**Calculation Change Notice 2007-0033 for DA-EE-92-120-01  
“Diesel Generator B Steady State Loading Analysis”**

# ATTACHMENT 2, CALCULATION CHANGE NOTICE (CCN) COVERSHEET

**Design Analysis**  
**Diesel Generator B Steady State Loading Analysis**

**DA-EE-92-120-01**

**Figure 3 - EDGB Frequency (Hz) during 1996 RSSP2.2**

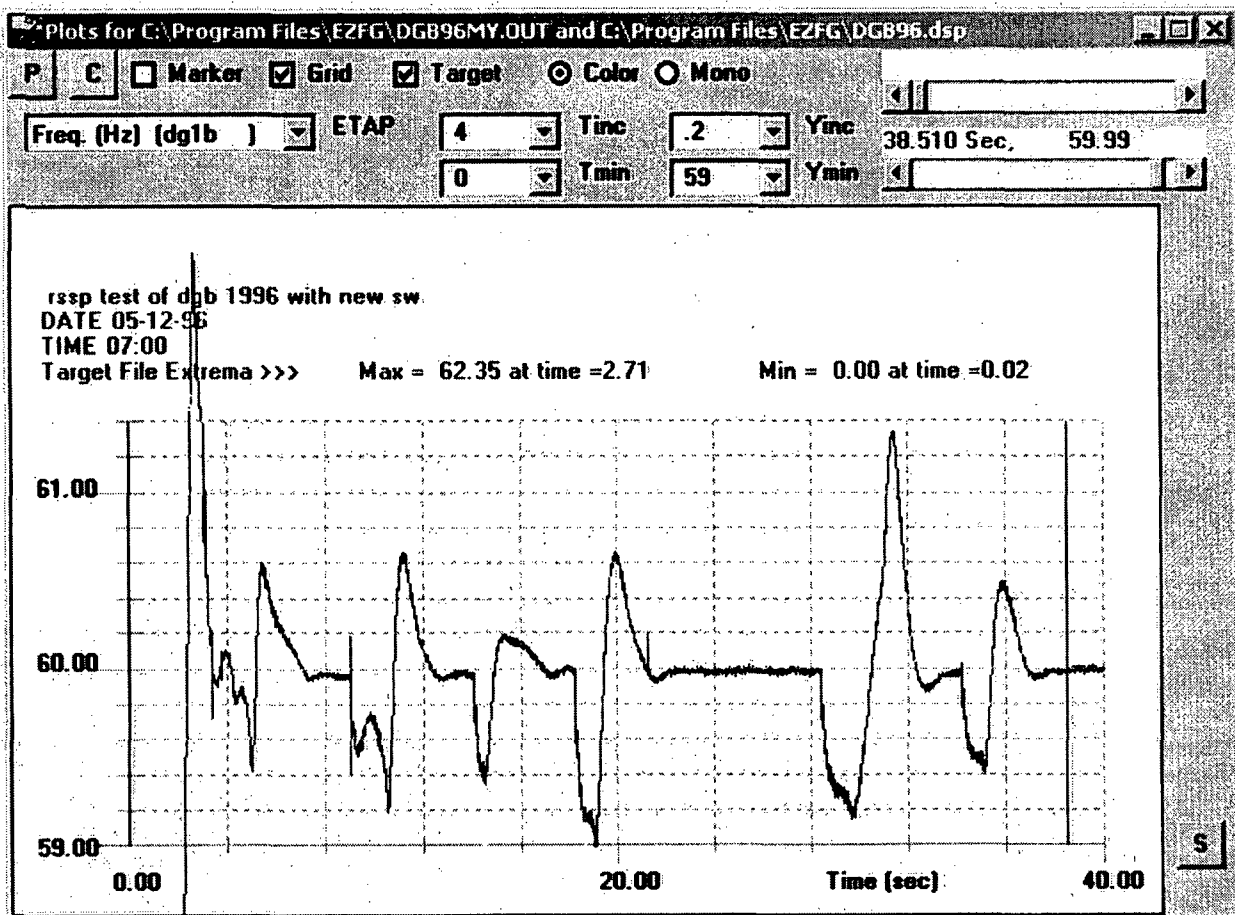
The above figure demonstrates that the final frequency was 59.99 Hz which can be considered to be within the setting acceptance criteria identified in PT-12.2 (60.0 to 60.1 Hz) when the value is rounded to one significant digit. As previously mentioned, the final kW load on the EDG during the above test was 1150 kW. While this loading is below the anticipated injection phase loading of 1930 kW, the above test does give a good indication of the EDGs frequency management capability during loaded conditions. The above curve also demonstrates that this capability is not diminished as more load is added during the sequence. The most recent RSSP2.2 test (10/11/06) recorded a steady state frequency of 60 Hz after the loads had been sequenced on. Based on the above results and discussions, it can be concluded that a reasonable estimate of the EDGs frequency management capability during accident conditions, according to the MCB meter, would be a frequency range between 59.5 Hz and 60.1 Hz (~~Note that the upper frequency limit was reduced from the 60.5 Hz value noted in PT12.2 based on the 1996 field measurements~~). The accuracy of the meters on the main control board are  $\pm 0.3$  Hz. so the actual steady state EDG frequency during accident conditions can be expected to be within the following range:

60.8

HOWEVER A FREQUENCY RANGE BETWEEN 59.5 HZ AND 60.5 HZ WILL BE USED.

since the majority of the load on the EDG is this type of load, it is reasonable to assume that the kW load on the EDG would be 1.02 times greater at 60.4 Hz, as compared to the 60Hz kW loading value.
